CITY OF WESTMINSTER			
PLANNING APPLICATIONS COMMITTEE	SUB	Date 22 October 2019	Classification For General Release
Report of Director of Place Shaping and Town Planning		Ward(s) involved St James's	
Subject of Report	7-8, Langley Court, London, WC2E 9JY		
Proposal	Creation of a roof terrace with railings at main roof level.		
Agent	Mr Anthony Richardson		
On behalf of	Ingrid Paragyte		
Registered Number	19/05680/FULL	Date amended/ completed	24 July 2019
Date Application Received	19 July 2019		
Historic Building Grade	Unlisted		
Conservation Area	Covent Garden

Proposed Roof Plan.

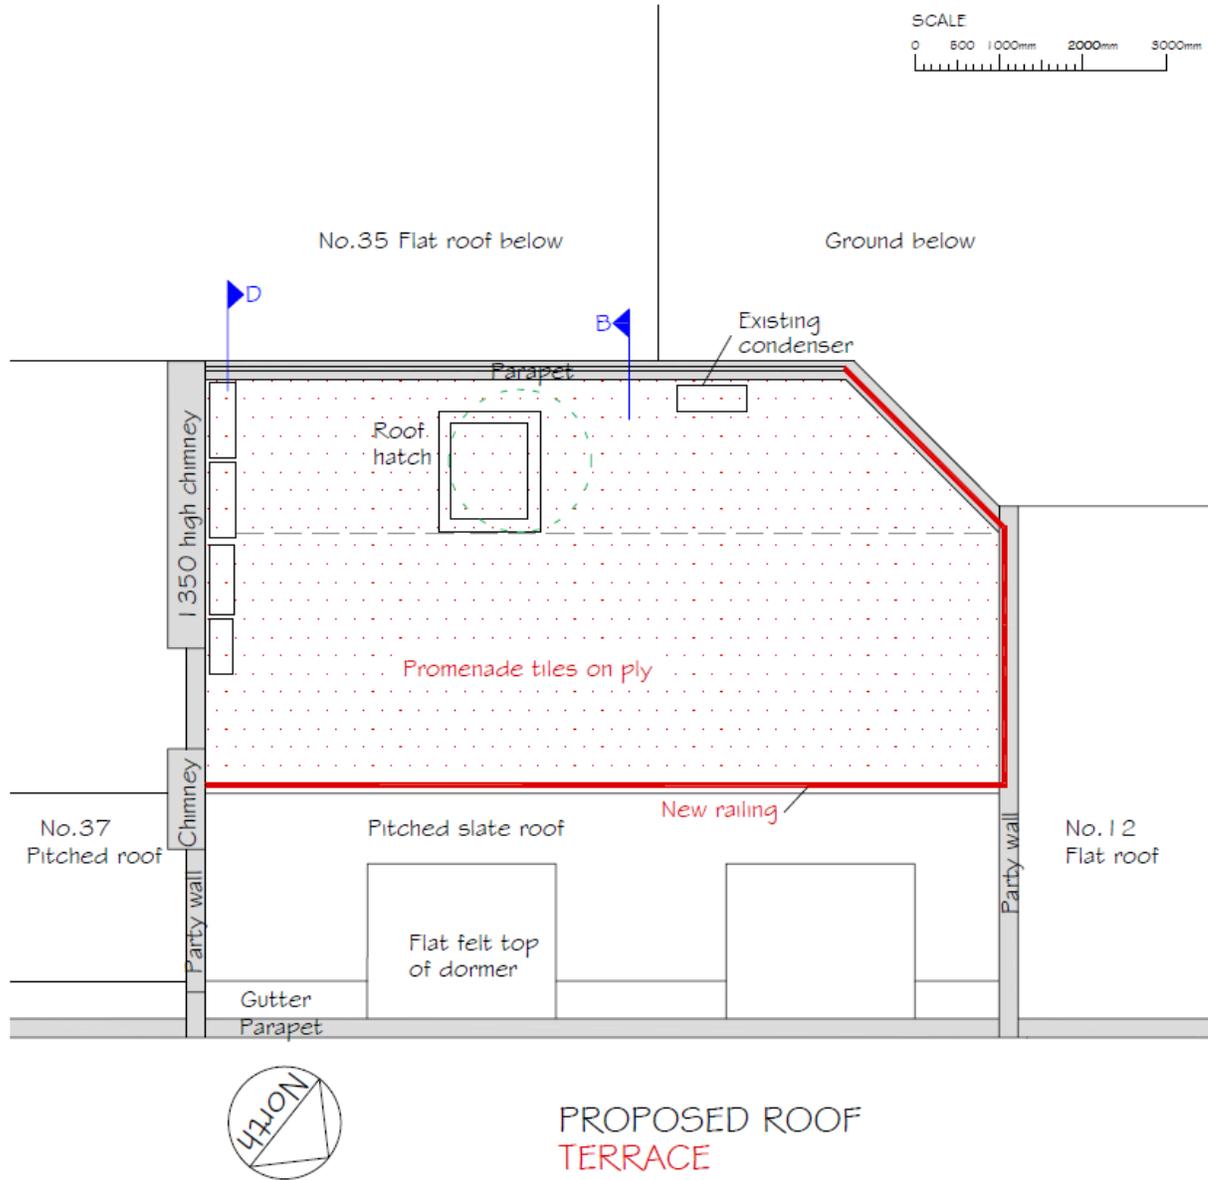
Raise an objection. The proposed roof terrace overlooks a quiet residential court which is shared with many residential properties on Floral Street and Long Acre. Floral Street is one of the few peaceful areas left in Covent Garden. A new roof terrace for use by office workers would disrupt that peace.

Floral Street and Long Acre, adjacent to Langley Court has many residential properties at higher level who will be disturbed by the use of the roof as a terrace at this site. Object to the use of the flat roof as a terrace unless there are stringent conditions put in place to avoid unnecessary nuisance to the residents in the area and also the office users on the upper adjacent floors.

A solid barrier should be put in place and at a height to avoid any overlooking to the residential or sensitive office areas and be sufficiently set back so that it is not visible from the street. Use of the terrace must be limited to 7pm and only used by the office workers and not for entertaining or events. No music to be played on the terrace and no smoking.

- The proposed roof terrace overlooks a quiet residential court which is shared with many residential properties on Floral Street and Long Acre. At the moment it is a haven of peace but if there is a new terrace used by office workers that quiet will be shattered.

Given the nature of the existing roof slope, the proposed railings will be set-back from the front elevation of the building by approximately 3m and they will not therefore be readily visible at street level. A condition is recommended to secure details of the metal railings. The proposal is therefore considered acceptable in design and conservation terms, in accordance with Policies DES 1, DES 6 and DES 9 of the Council's Unitary Development Plan (adopted in 2007) and S25 and S28 of Westminster's City Plan (adopted in 2016).

The proposed terrace will be used in connection with the existing office use and conditions are therefore recommended restricting the hours of use of the terrace to between 08:00 until 19:00 on week days only and to ensure that no amplified music is played on the terrace to protect the amenity of neighbouring residents in terms of noise and disturbance.

- 5 The roof terrace level shall only be used between the hours of 0800 and 1900 Monday to Friday.

- 6 No amplified music shall be played on the roof terrace.

- new railings around the perimeter of the terrace.
